# Ground Floor Plan

S4.55 COMPARISON

# Level 06 Plan

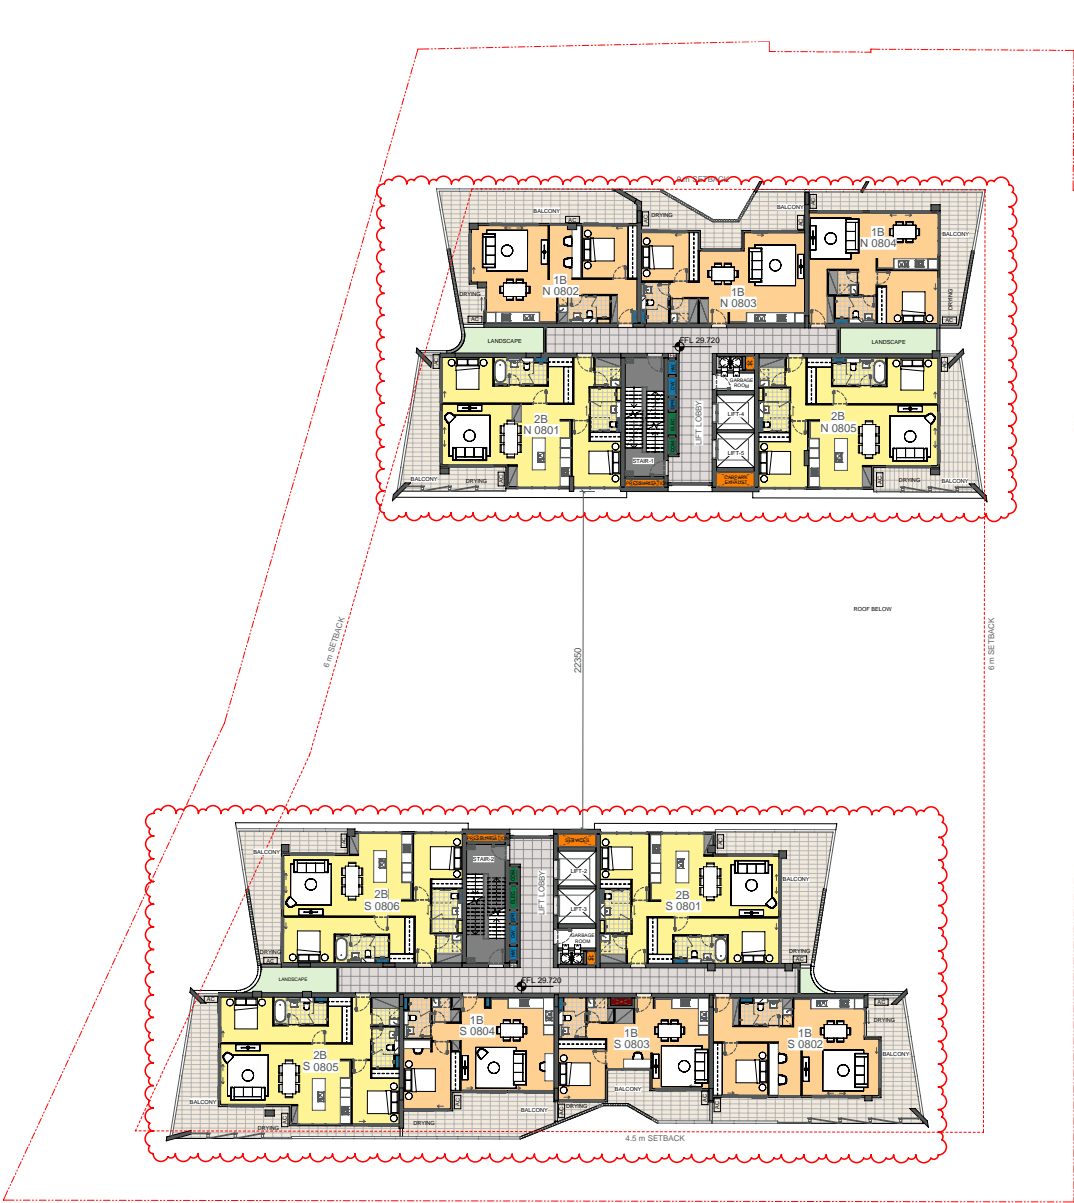
- 1. Lobbies changed - lift locations, consolidated with stair following structural input
- 2. Setbacks to boundaries remains the same
- 3. Minor planning changes to units generally including external footprint:
  - a) N0602 changed from 1 bed to 2 bed
  - b) S0604 changed from 1 bed to 2 bed
- 4. Minor alterations to tower geometry and construction detail
- 5. Landscaping removed from buildings central axis.  
Vertical external screens added.
- 6. Carpark exhaust has been relocated to southeast
- 7. Roof garden and solar panels added to roof.  
Separation between south tower and duplex roof has decreased

# Level 08 - Typical Tower

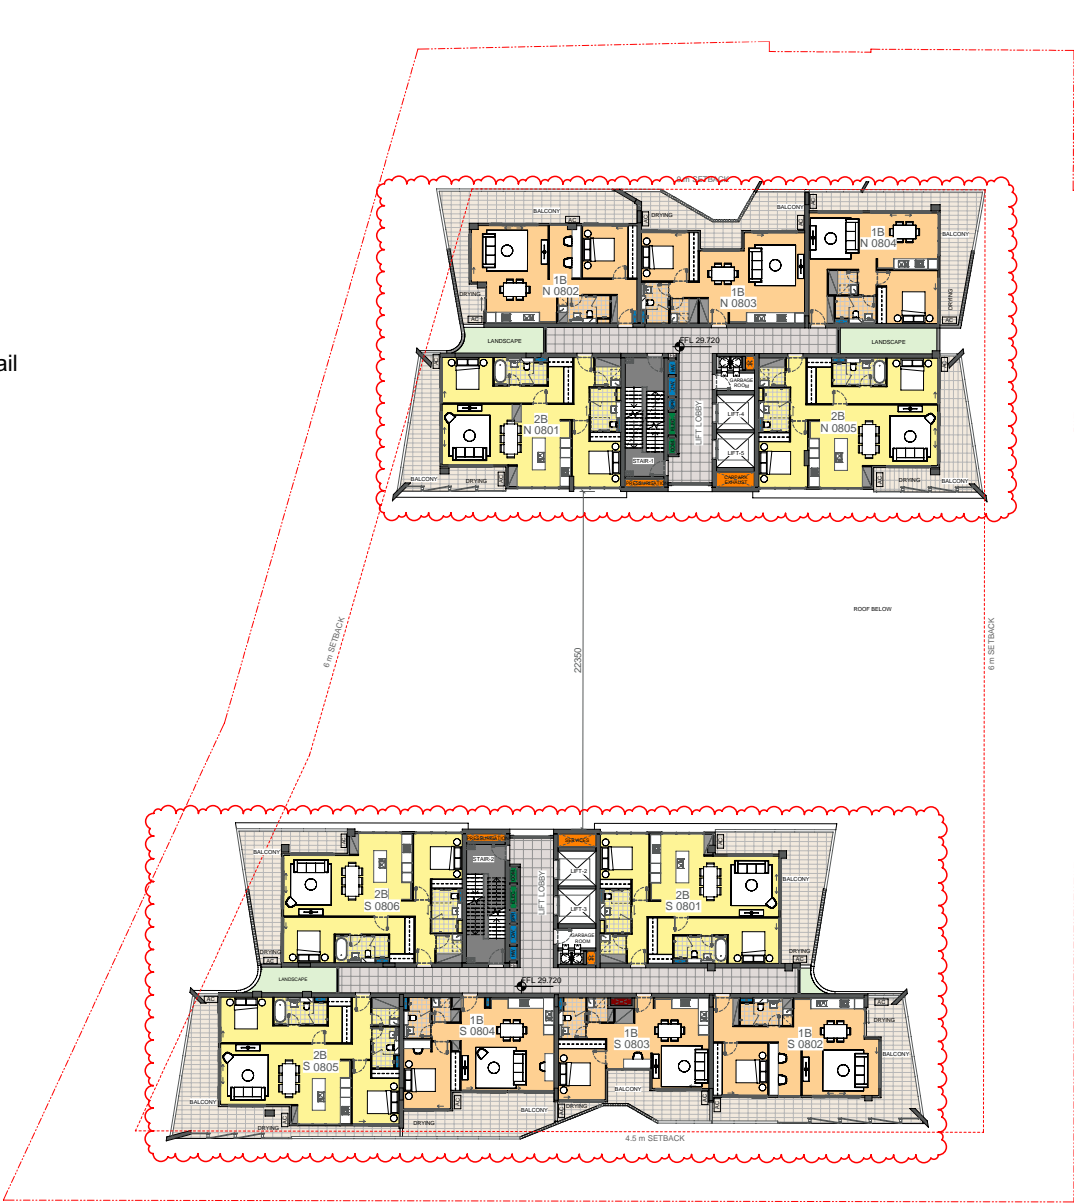
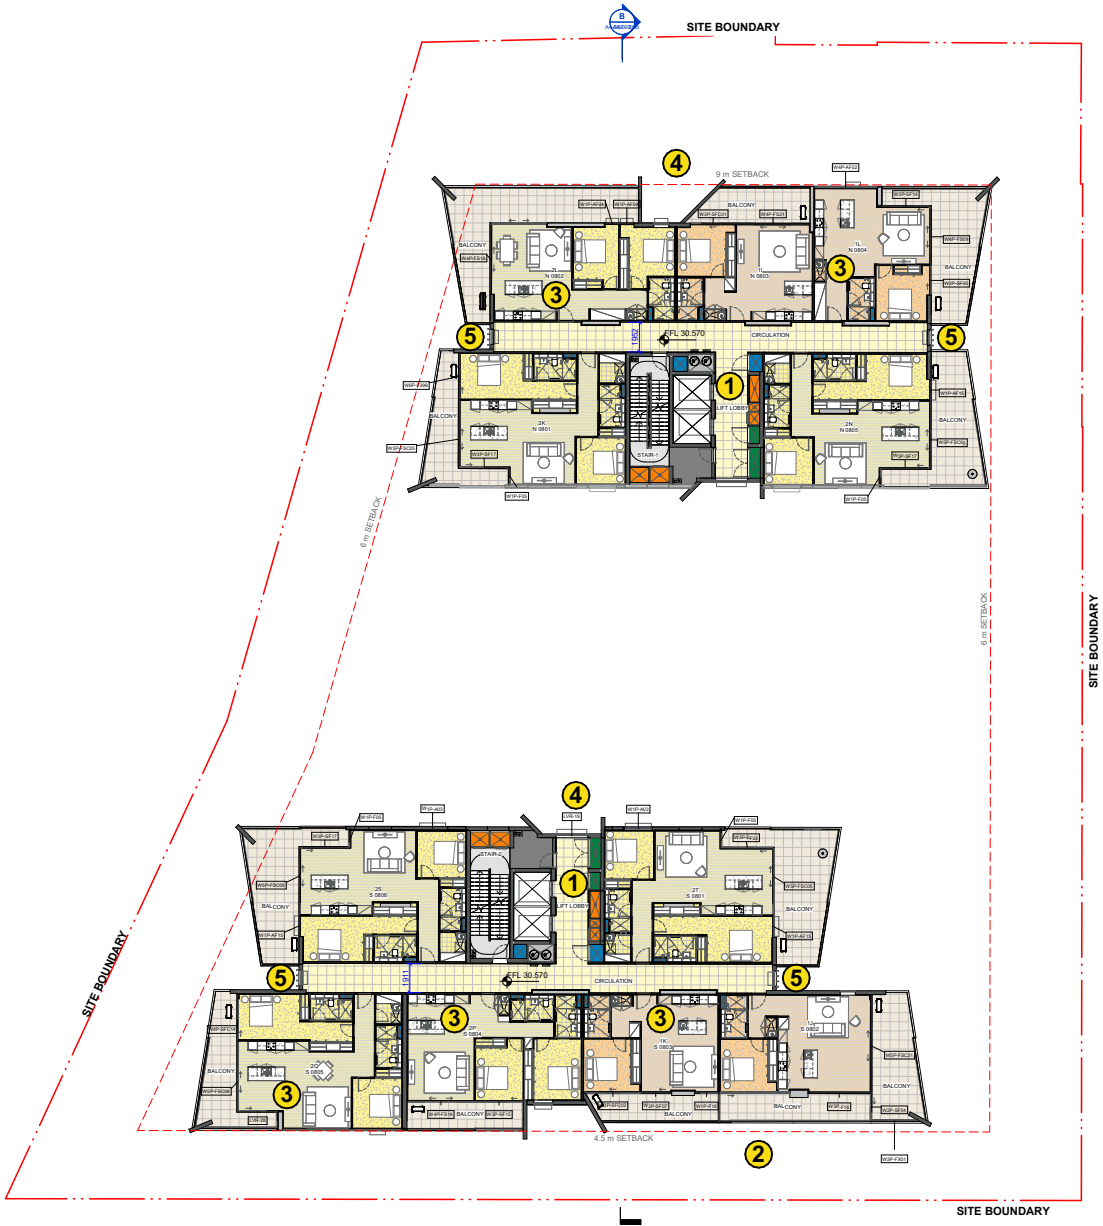
- 1. Lobbies changed - lift locations, consolidated with stair following structural input
- 2. Setbacks to boundaries remains the same
- 3. Minor alterations unit layouts and circulation
  - a) Unit S0804 changed from 1 bed to 2 bed
  - b) Unit N0802 changed from 1B to 2B
  - c) Minor planning changes to units generally including external footprint
- 4. Minor alterations to tower geometry and construction detail
- 5. Landscaping removed from buildings central axis.  
Vertical external screens added.

# Level 18 - Planning

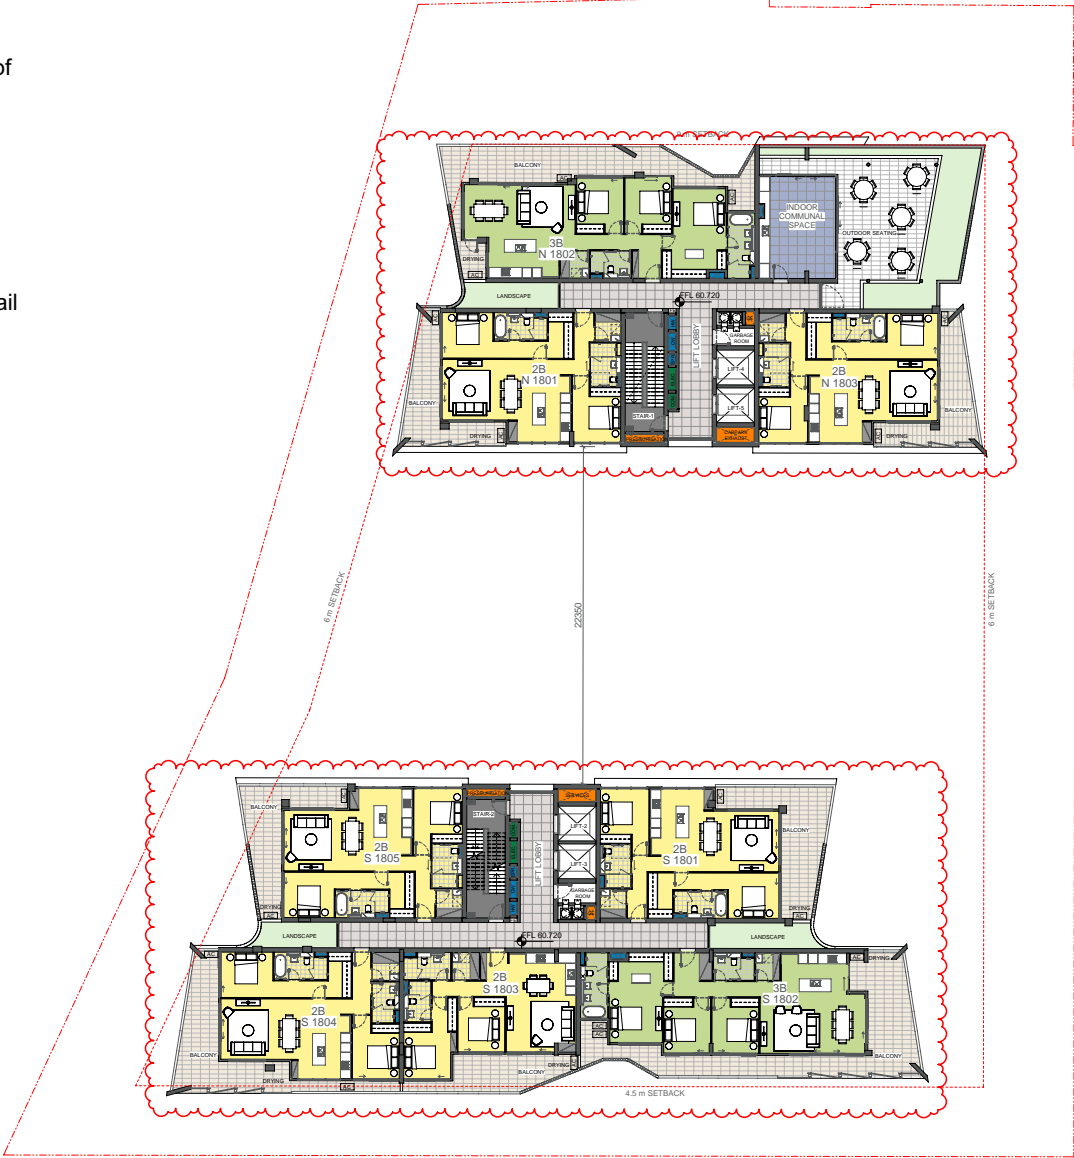
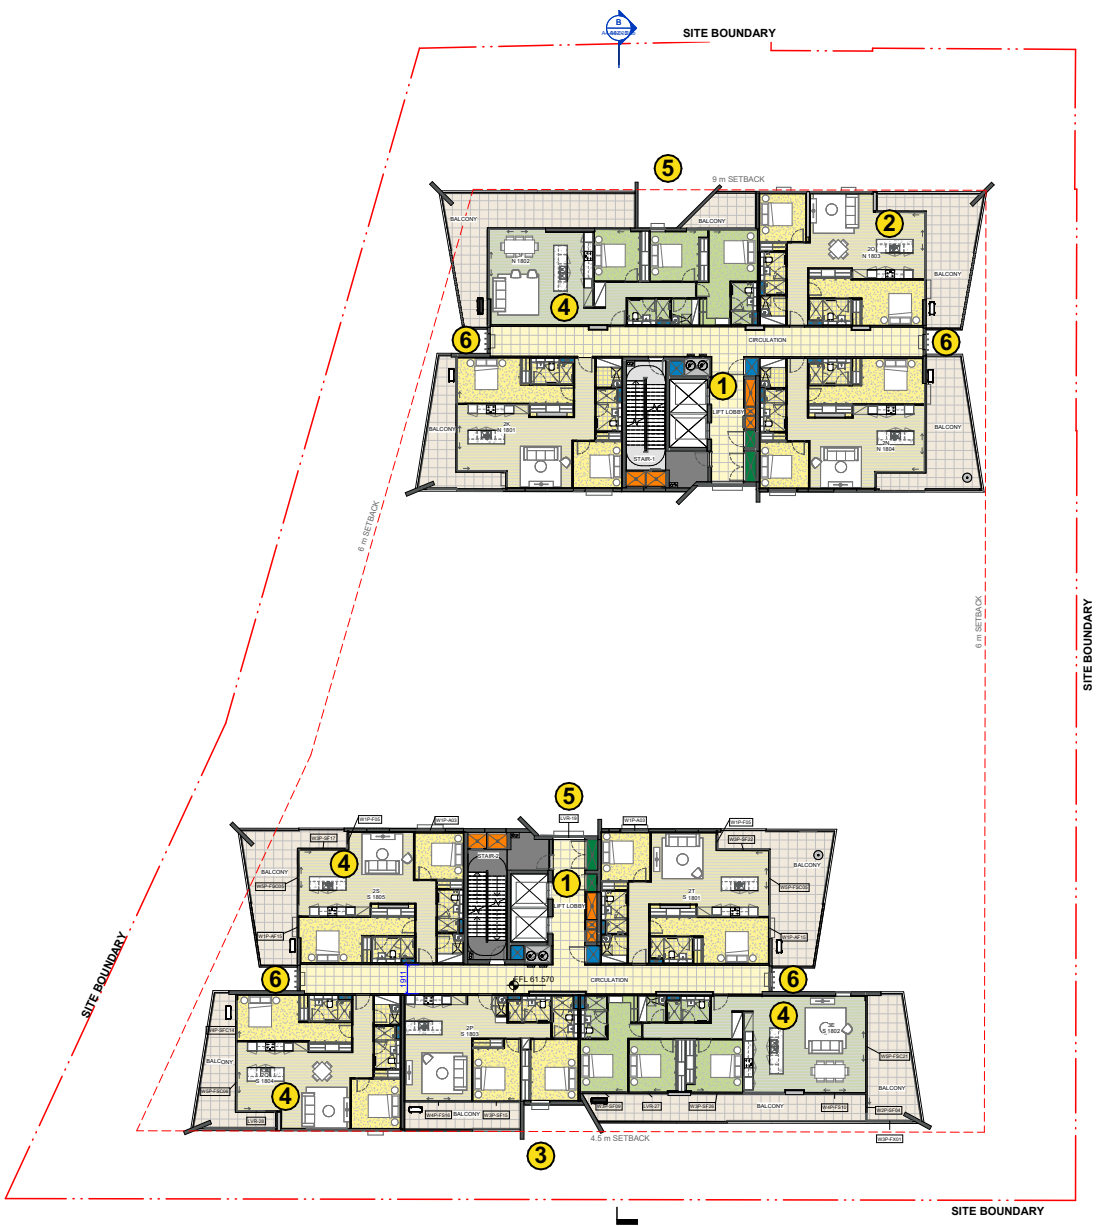
- 1. Lobbies changed - lift locations, consolidated with stair following structural input
  - 2. Communal space removed in line of unit too NW corner of north tower
  - 3. Setbacks to boundaries remains the same
  - 4. Minor alterations unit layouts and circulation
    - a) Minor planning changes to units generally including external footprint
  - 5. Minor alterations to tower geometry and construction detail
  - 6. Landscaping removed from buildings central axis
- Vertical external screens added.

# Level 19 - Planning

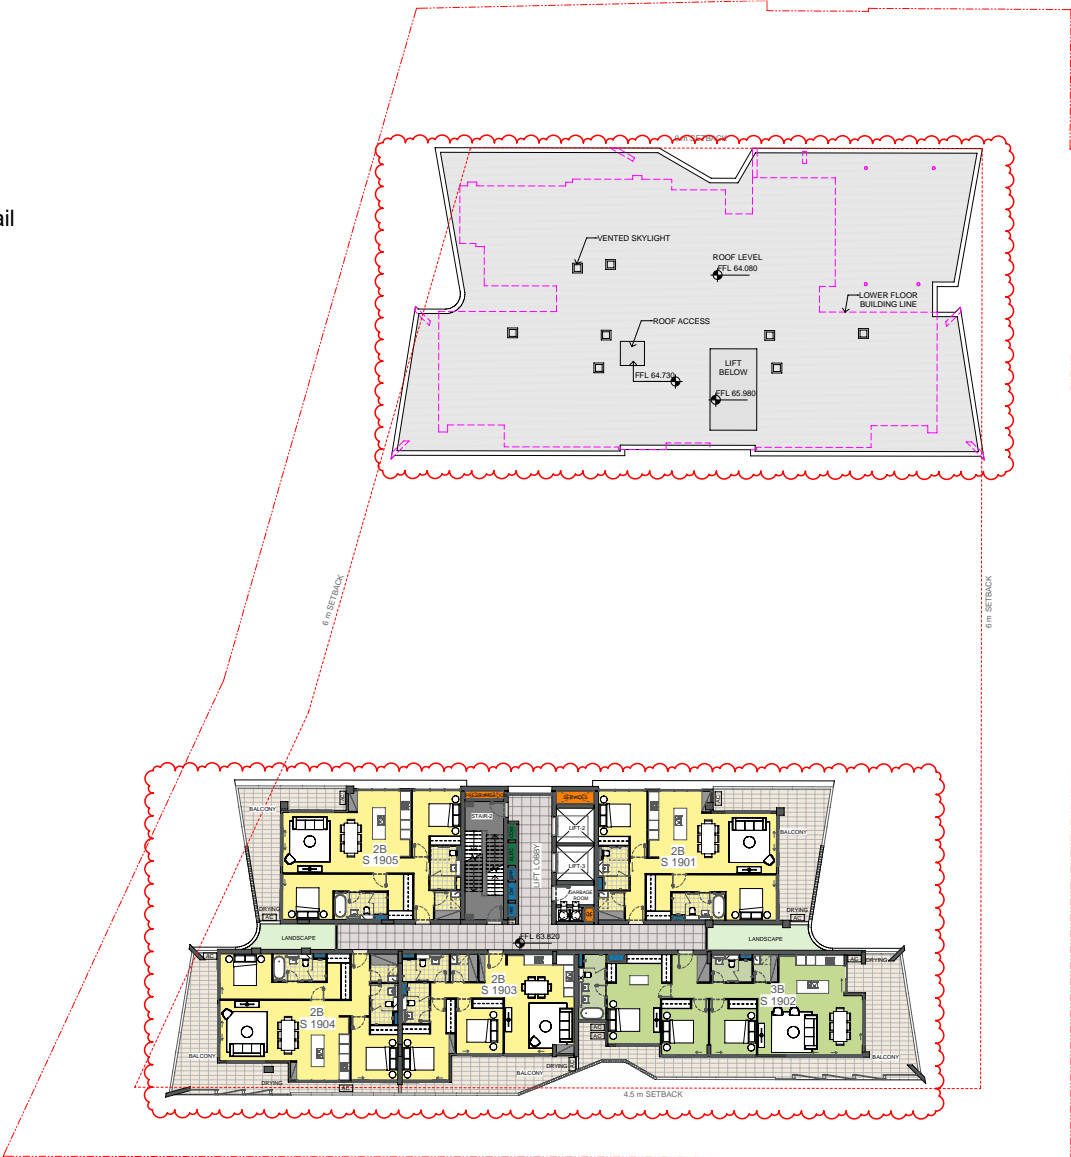
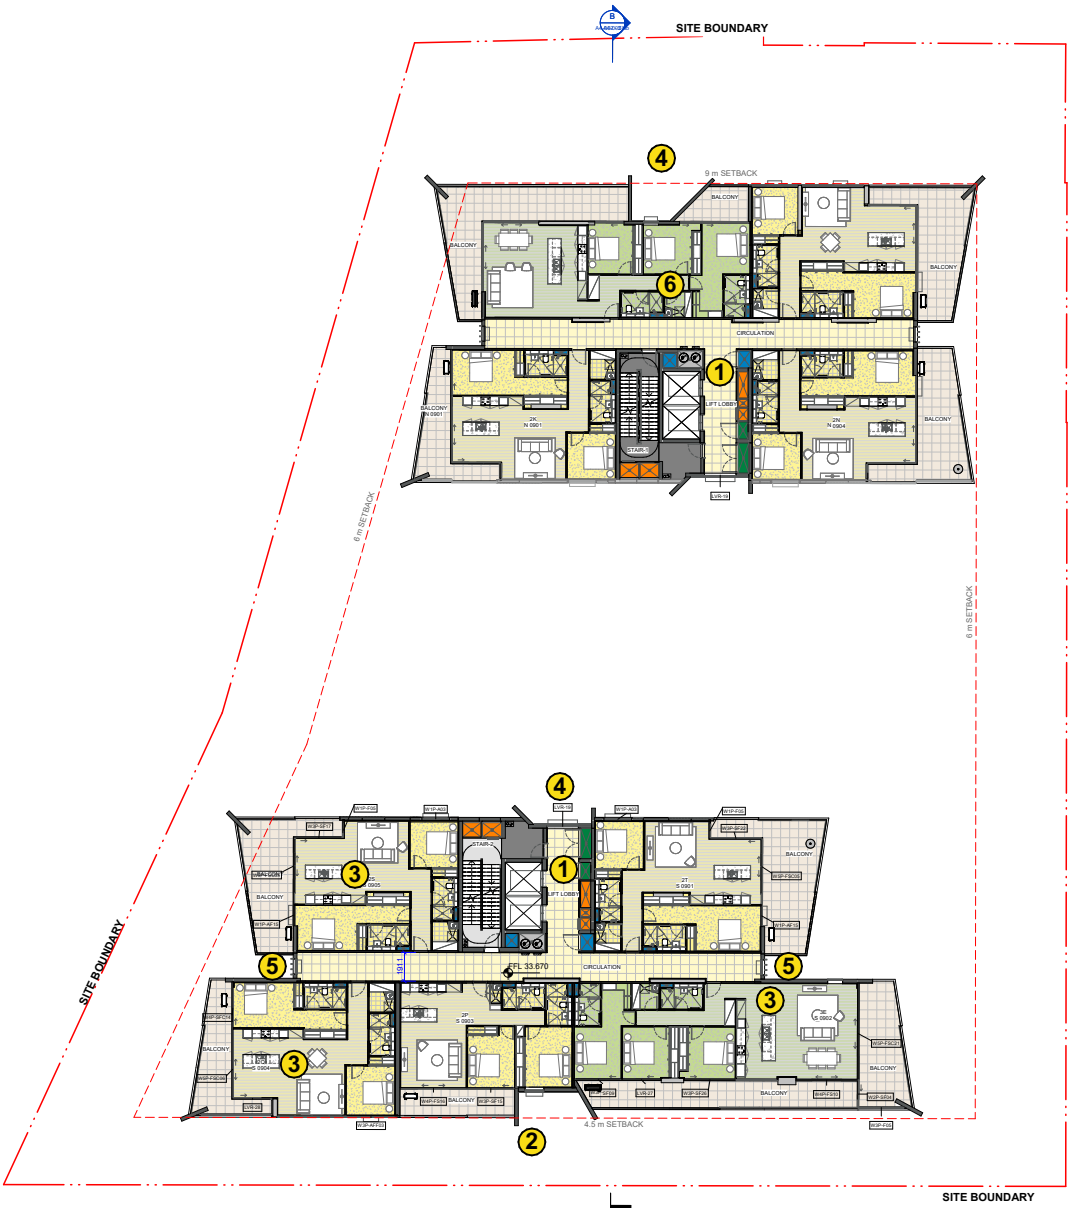
- 1. Lobbies changed - lift locations, consolidated with stair following structural input
- 2. Setbacks to boundaries remain the same
- 3. Minor alterations unit layouts and circulation
  - a) Minor planning changes to units generally including external footprint
- 4. Minor alterations to tower geometry and construction detail
- 5. Landscaping removed from buildings central axis
  - Vertical external screens added.
- 6. Additional level added to North tower, comprised of communal space, solar and services
